**CITY OF NAPLES
PURCHASING DIVISION
CITY HALL, 735 8TH STREET SOUTH
NAPLES, FLORIDA 34102
PH: 239-213-7100 FX: 239-213-7105**

ADDENDUM NUMBER 1

NOTIFICATION DATE:	SOLICITATION TITLE:	SOLICITATION NUMBER:	BID OPENING DATE & TIME:
2/5/2021	Lake Restoration & Improvements Project (Lakes 11, 31, & 19) - RFP	21-018	2/19/2021 2:00PM

Exhibit A - Skimmer for Outlet Control Structures

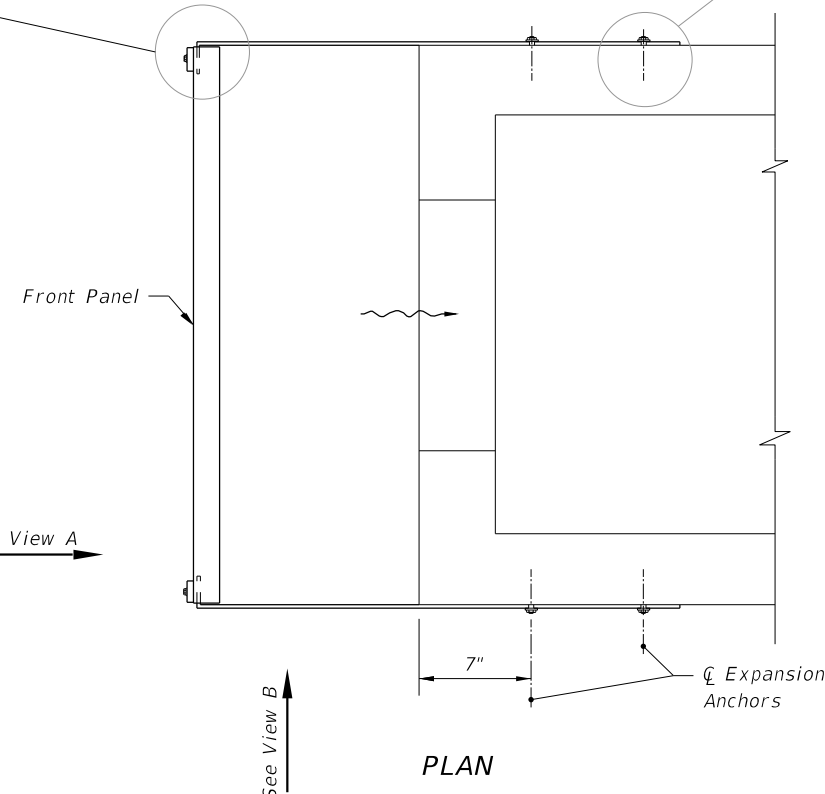
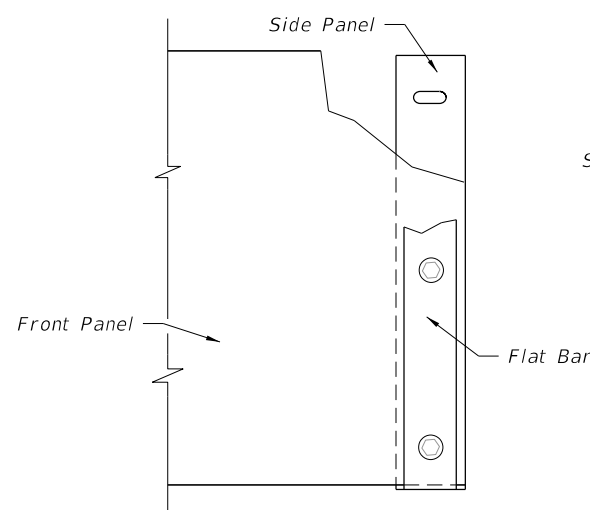
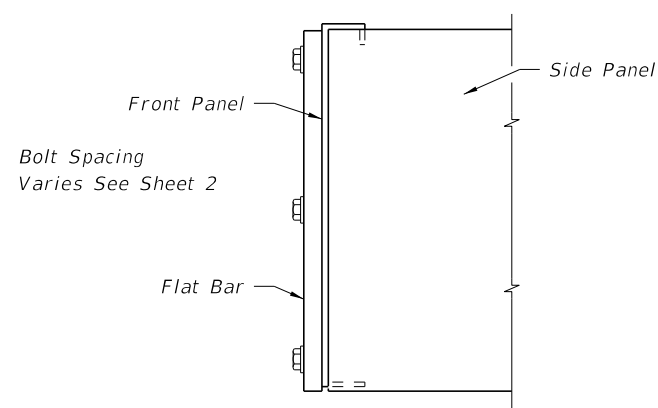
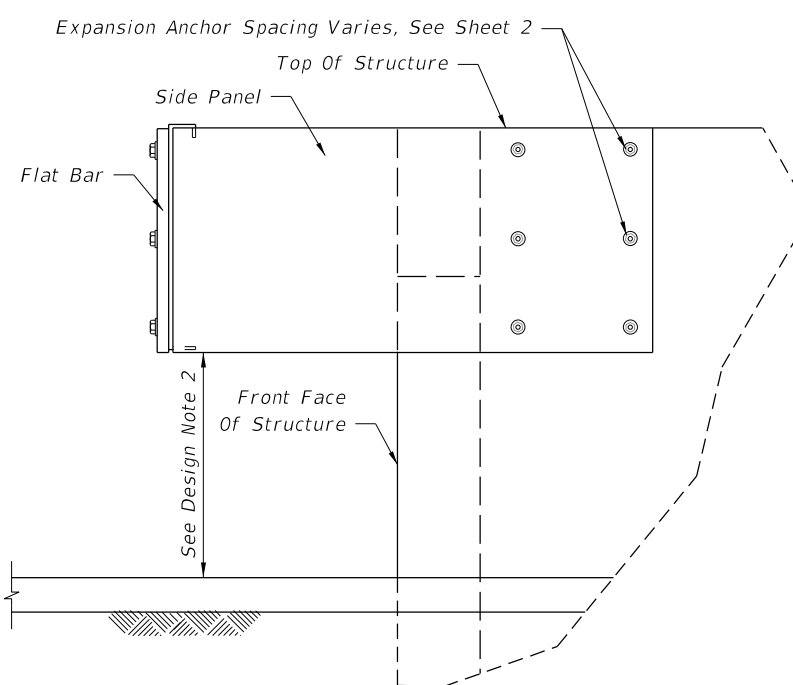
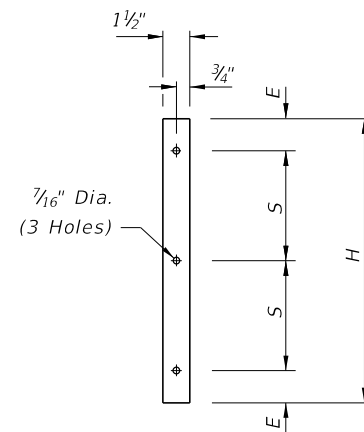
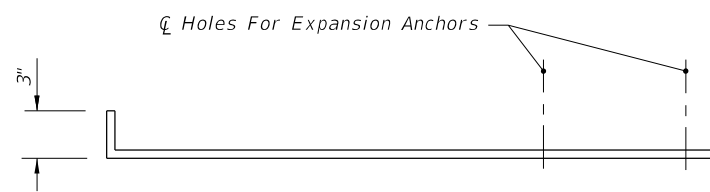
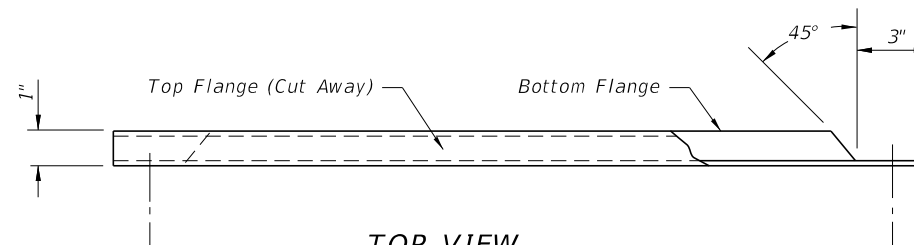
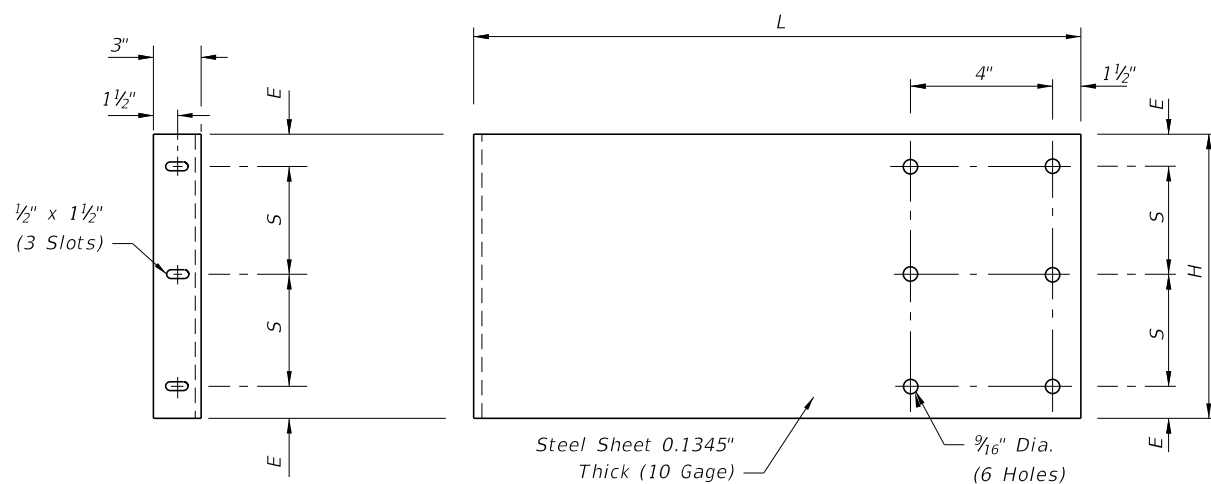
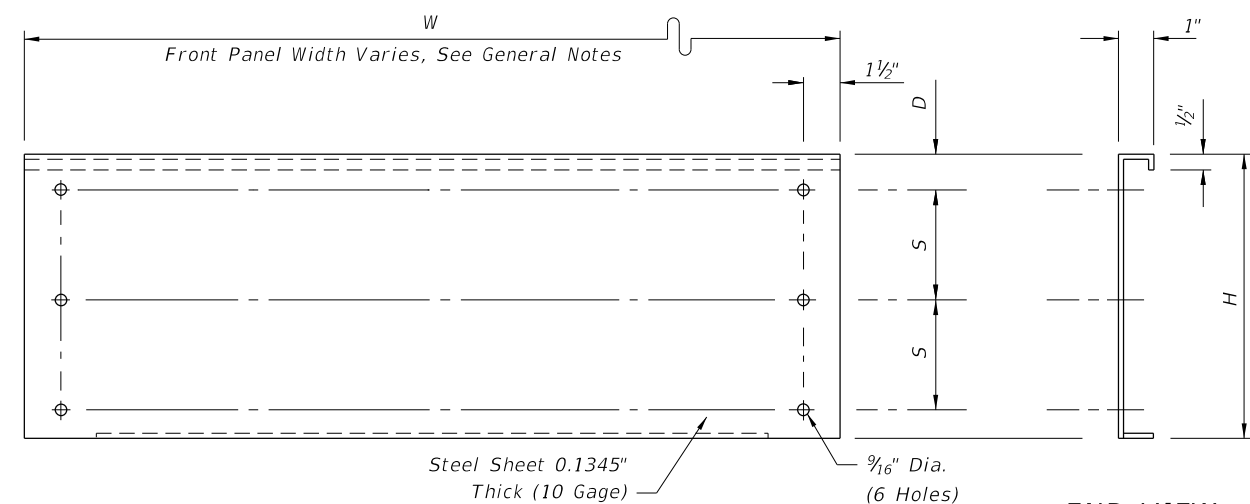
5. The Detail on sheet 41 called out as "Skimmer Plate For Inlet Structure" is not legible.

ANSWER: See attached Skimmer Plate detail for review. The height of the skimmer plate should be 12".

SHEET TITLE:
PROPOSED SITE PLAN STAGE II: PUBLIC OUTREACH AMENITIES - LAKE 19

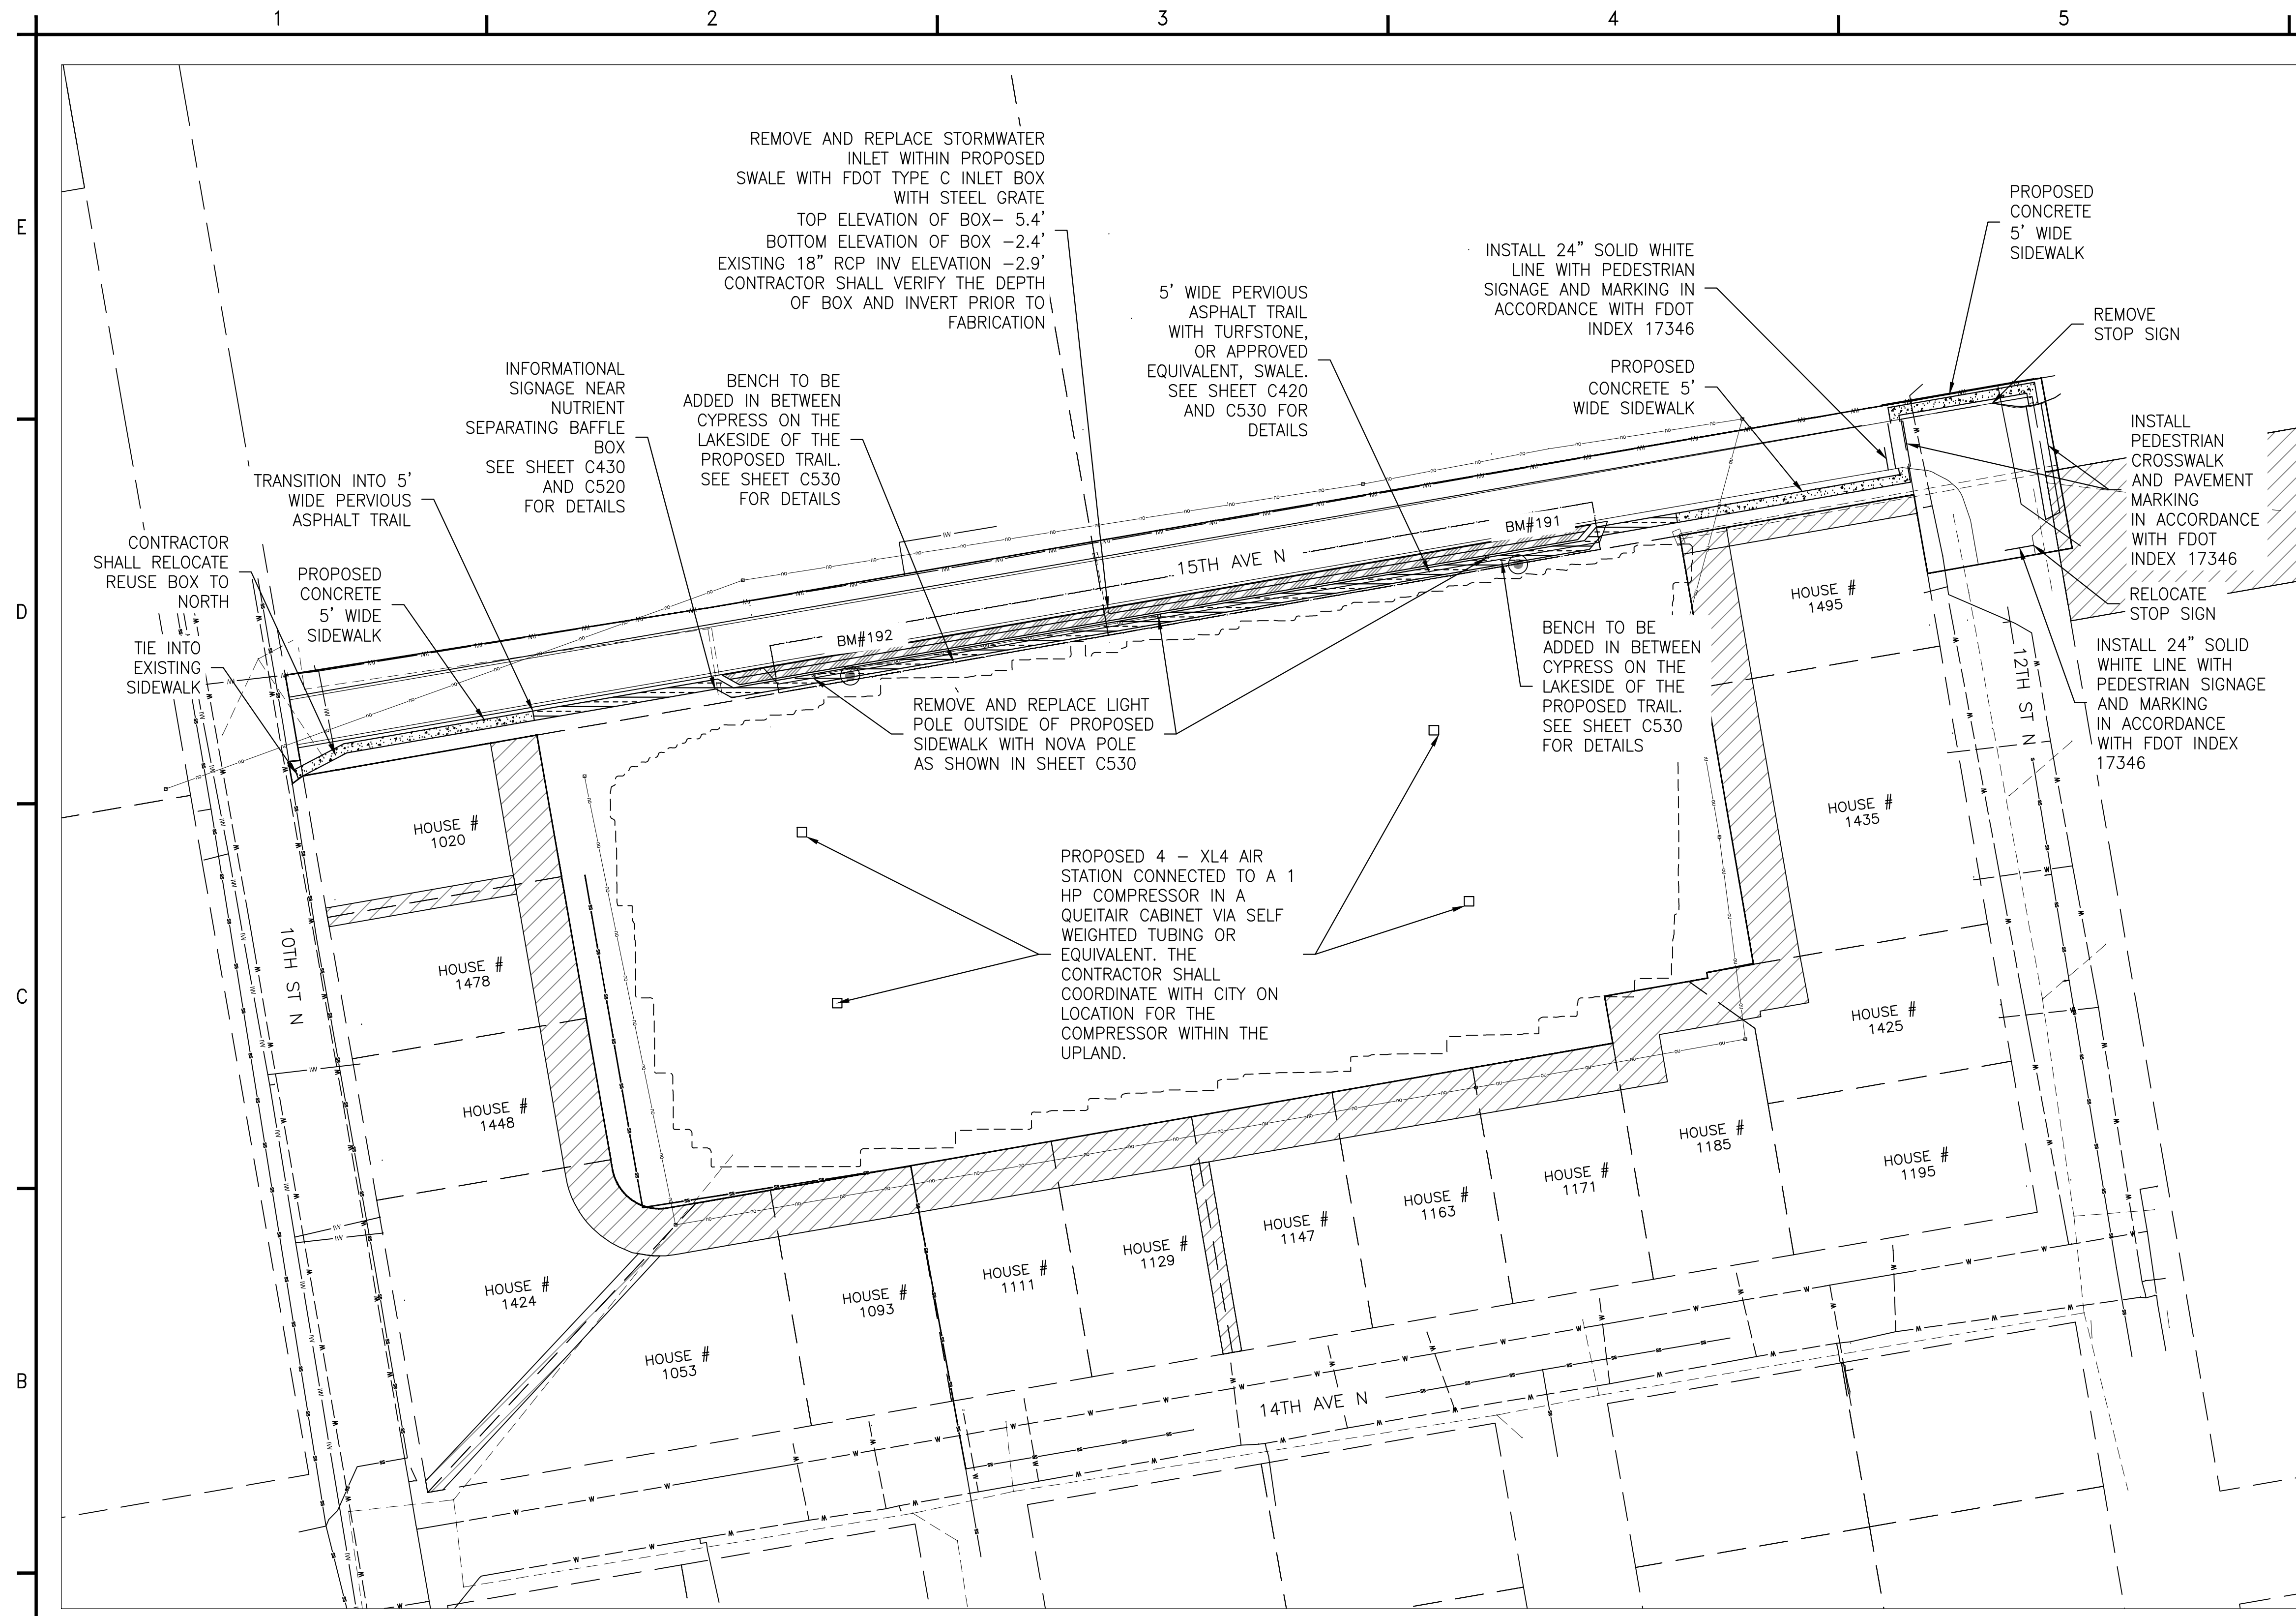
4. On Sheet 7 (Lake 19) there is a proposed FDOT type C Inlet. The Top elevation is given but there is no invert given. I assume the existing pipe is 18" per the preconditions plan on sheet 3. There is no information on the number of pipe inlets the structure has as well.

ANSWER: The note on sheet C221 has been revised to reflect the bottom of box elevation and invert elevation for the existing 18" reinforced concrete pipe. The Contractor shall verify the depth of box and invert prior to fabrication.

SHEET TITLE:
NORTH-SOUTH CROSS-SECTION LOCATIONS - LAKE 31

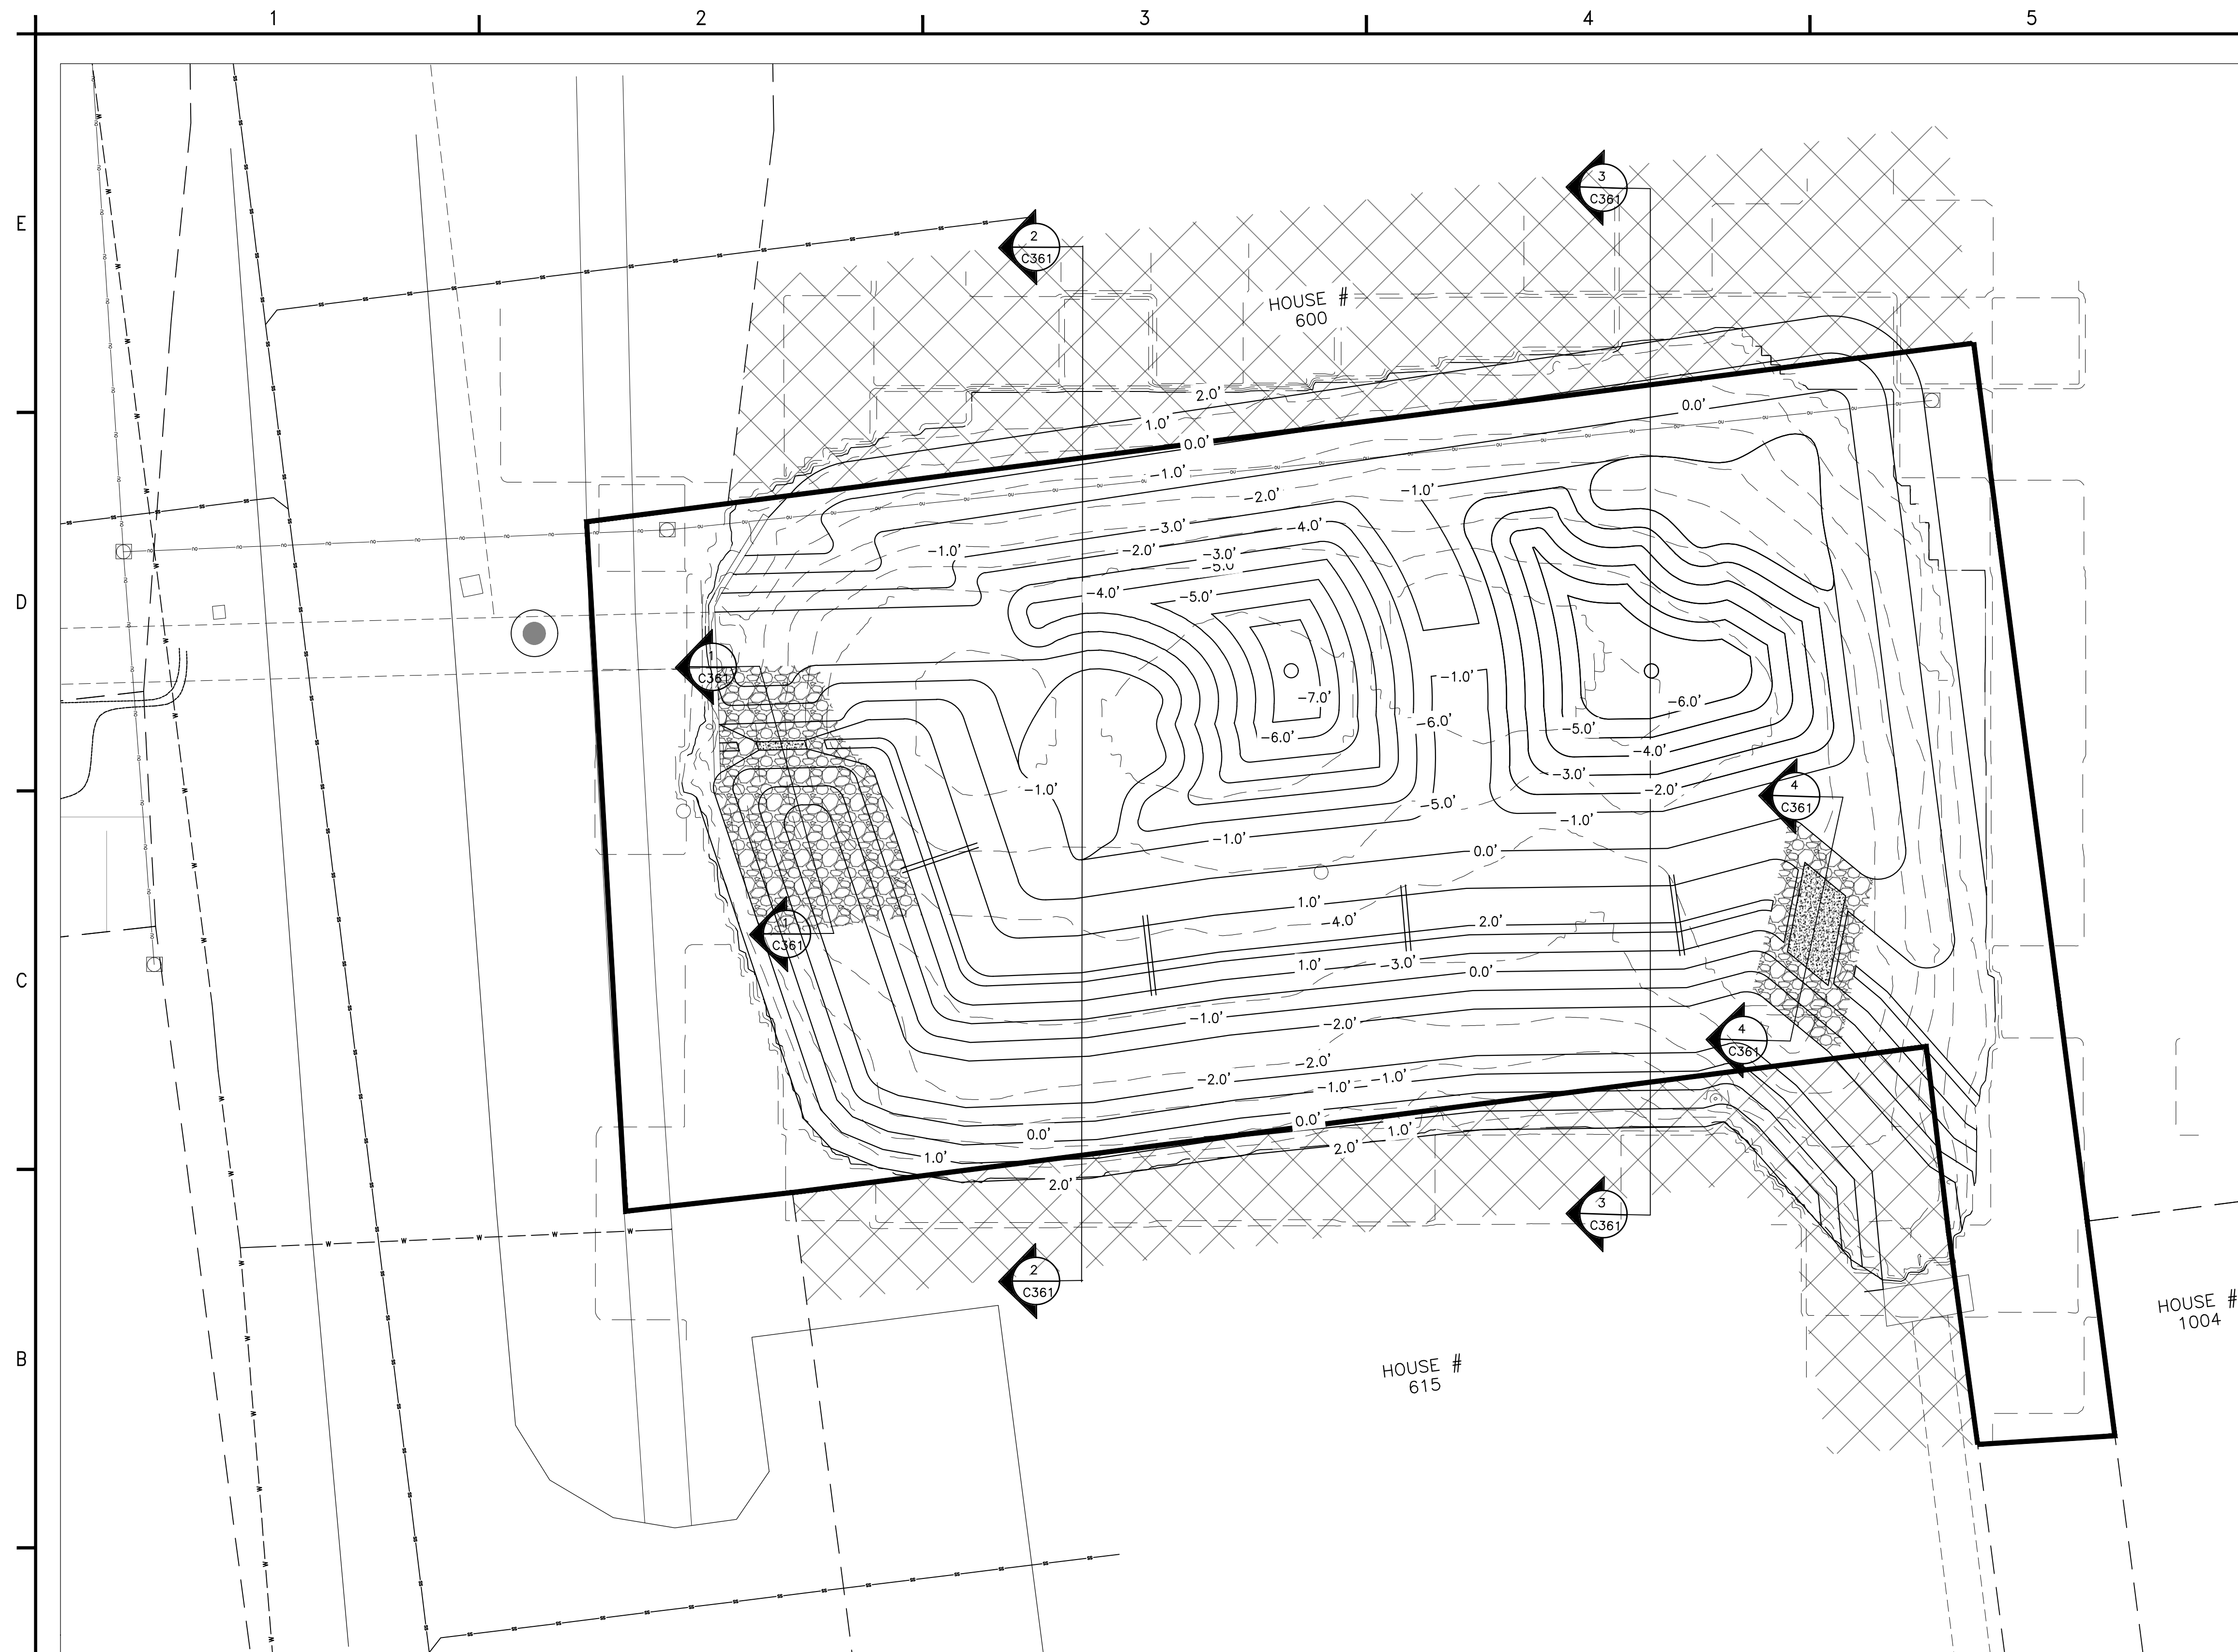
6. On Sheet 9 (lake 31) There are no details provided for either of the concrete weir structures.

ANSWER: On Sheet C223 there are two notes detailing the type of material, slopes, and elevations for each of the structures. Additional cross sections have been added to Sheet C360 and C361 for the concrete weir structures.
